METROPOLITAN GOVERNMENT OF NASHVILLE AND DAVIDSON COUNTY

STAFF RECOMMENDATION
1727 4th Avenue North
November 19, 2014

Application: Demolition; New construction-infill
District: Salemtown Neighborhood Conservation Zoning Overlay
Council District: 19
Map and Parcel Number: 08205001800
Applicant: John Root, architect
Project Lead: Robin Zeigler, robin.zeigler@nashville.gov

SIDE ELEVATION (TYP)

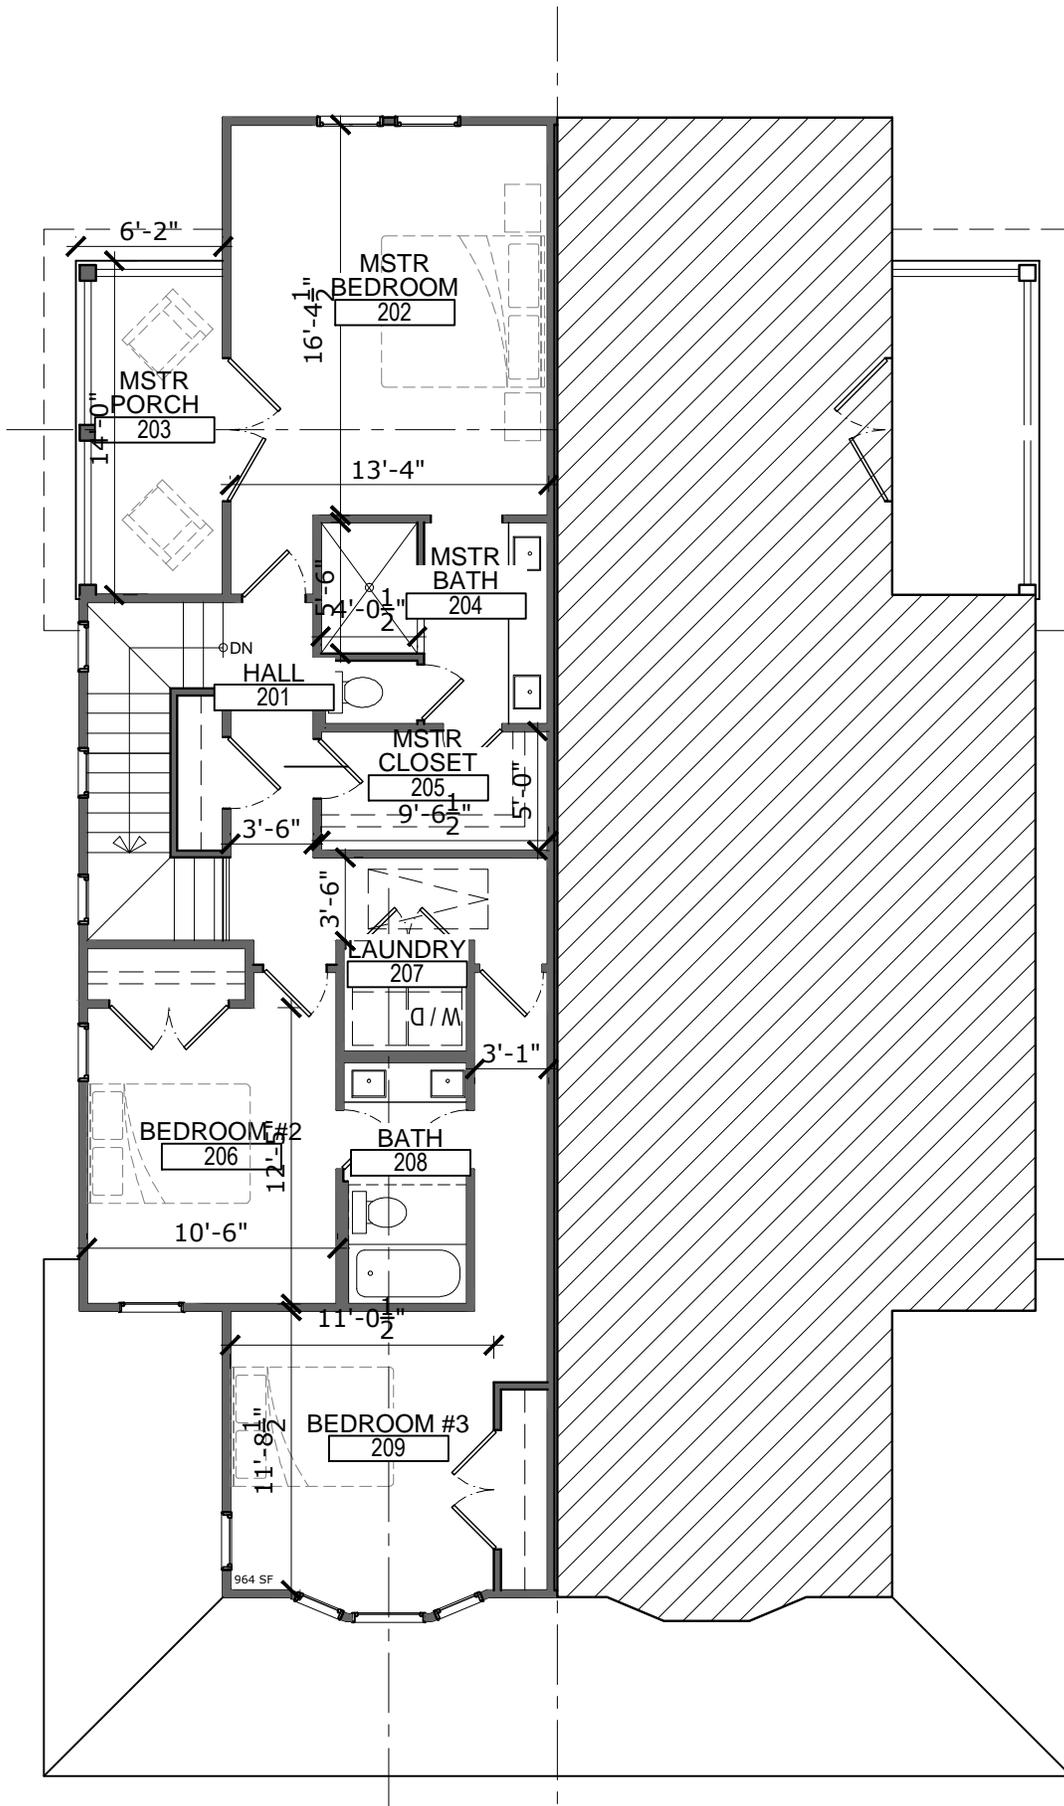
The foundation height will be approximately two feet (2') at the front. The porch eave height will be approximately nine feet (9') from the porch floor and the eave height for the house will be approximately twenty feet (20'). The ridge height is thirty-four feet and ten inches (34' 10") above grade. The design guidelines allow for a maximum of thirty-four feet in height. Since this maximum is well over the historic context, staff recommends lowering the height by ten inches (10").

colored asphalt shingle with standing seam metal on the porch. Staff asks to review the shingle color and the metal roof color. The trim and fence materials were not indicated. The windows are proposed to be fiberglass clad wood windows and the doors will be wood. Staff asks to approve the final window and door selections. The porch columns will be cement-fiber board. The material for the front porch floor and steps is concrete and the rear porch materials were not indicated. With the staff's final approval of the windows, doors, shingle color, and metal roof colors, trim, and rear porch and fence materials, staff finds that the materials meet section II.B.1.d of the design guidelines.

Proportion and Rhythm of Openings: The windows on the proposed addition are generally twice as tall as they are wide, thereby meeting the historic proportions of openings. There are no large expanses without an opening. Staff recommends that all paired windows have a four to six inch (4"-6") mullion between them. With this condition, staff finds the project's proportion and rhythm of openings to meet Section II.B.1.g. of the design guidelines.

1. The height be lowered by ten inches (10");
2. Staff approve the windows and doors, shingle color, metal roof color, trim, and fence and rear porch materials;
3. The HVAC units be located on the rear façade, or on a side façade beyond the midpoint of the house;
4. All paired windows have a 4" to 6" mullion; and
5. The finished floor height shall be consistent with the finished floor heights of the adjacent historic houses, to be verified by MHZC staff in the field.

SITE PLAN

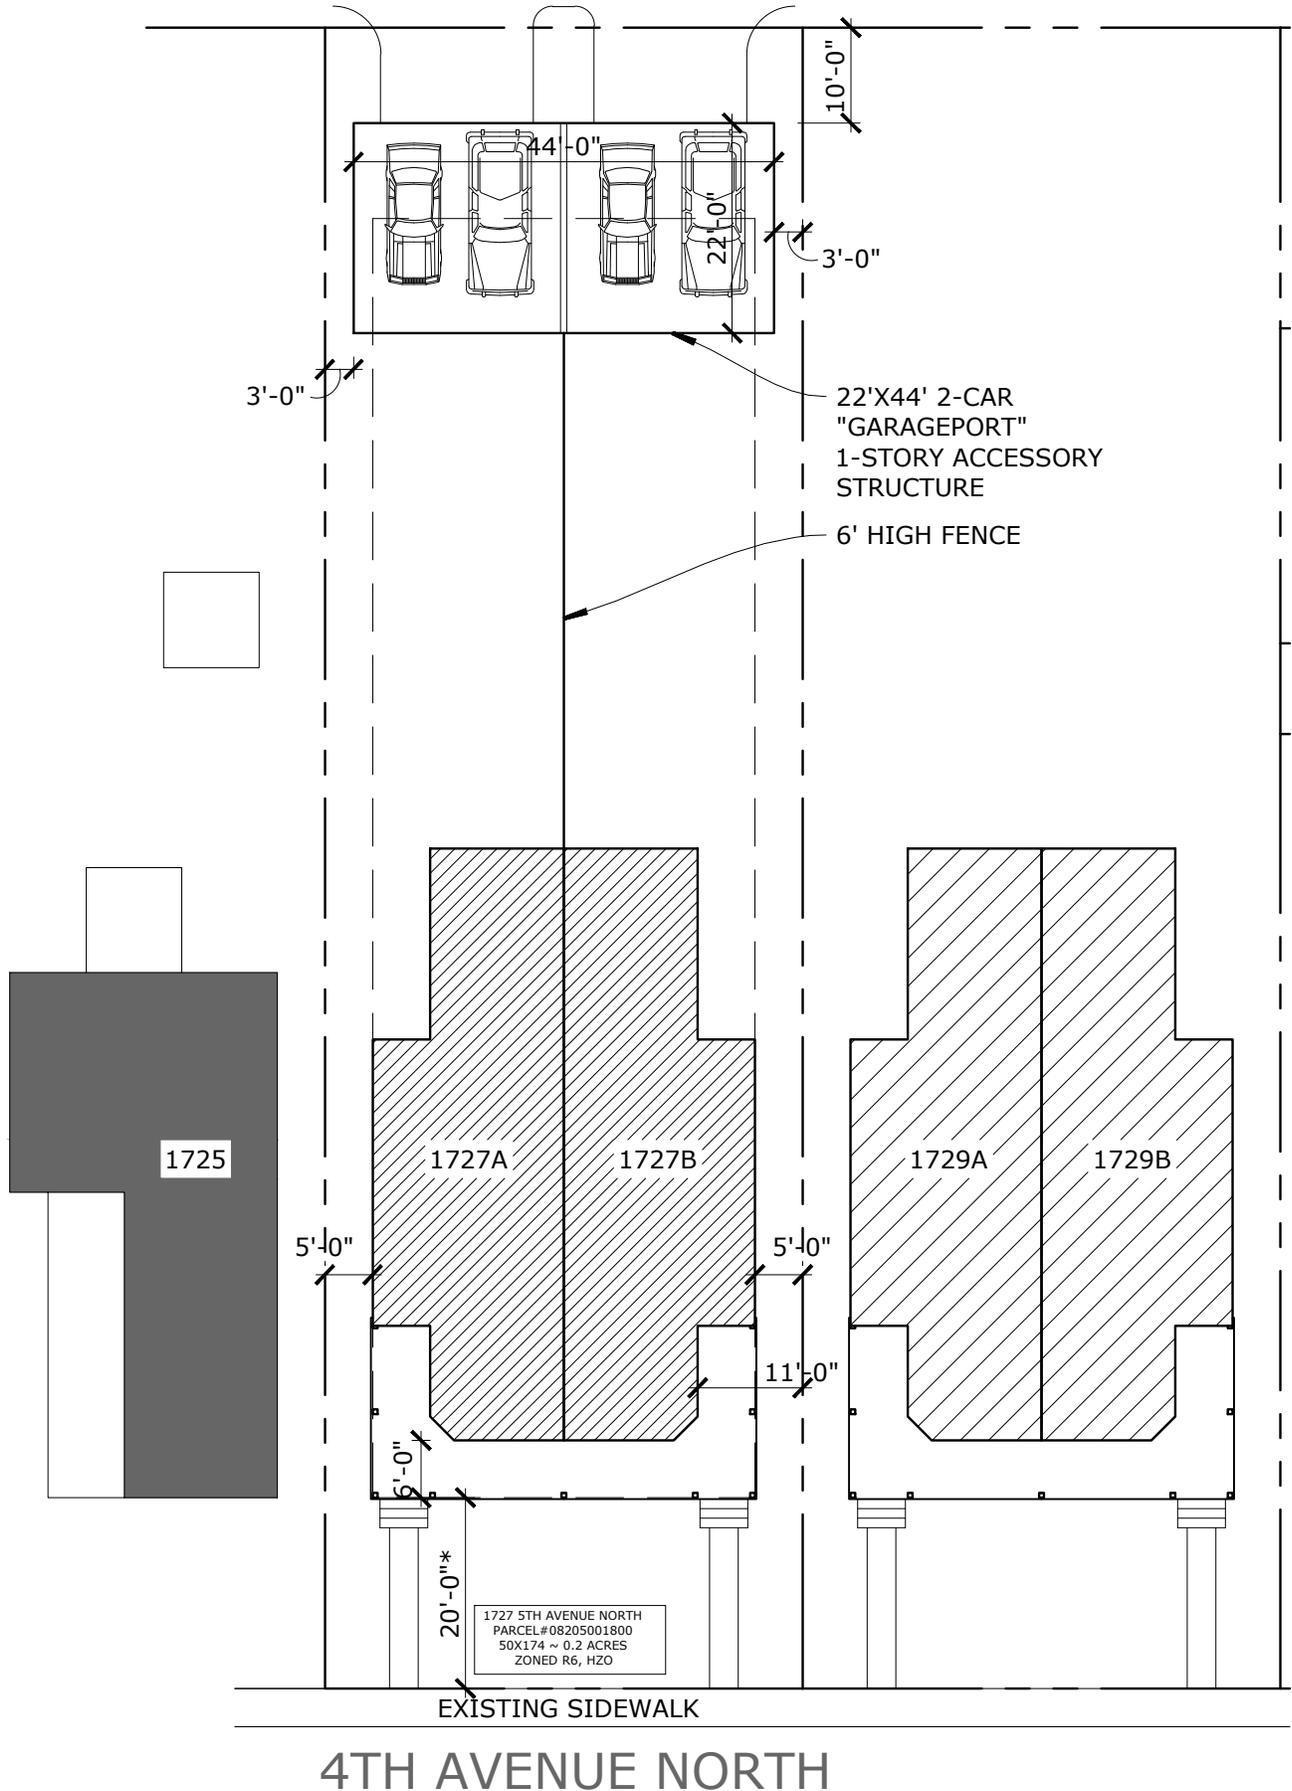
Appurtenances & Utilities: The location of the HVAC and other utilities was not noted. Staff asks that the HVAC units be located on the rear façade, or on a side façade beyond the midpoint of the house. A six foot fence will divide the rear yard.

Outbuildings: Although a four-bay garage or carport is shown on the site plan, no elevations were submitted. Staff has advised the applicant that a four-bay structure does not meet the design guidelines. Section II.B.1.h is not applicable at this time.
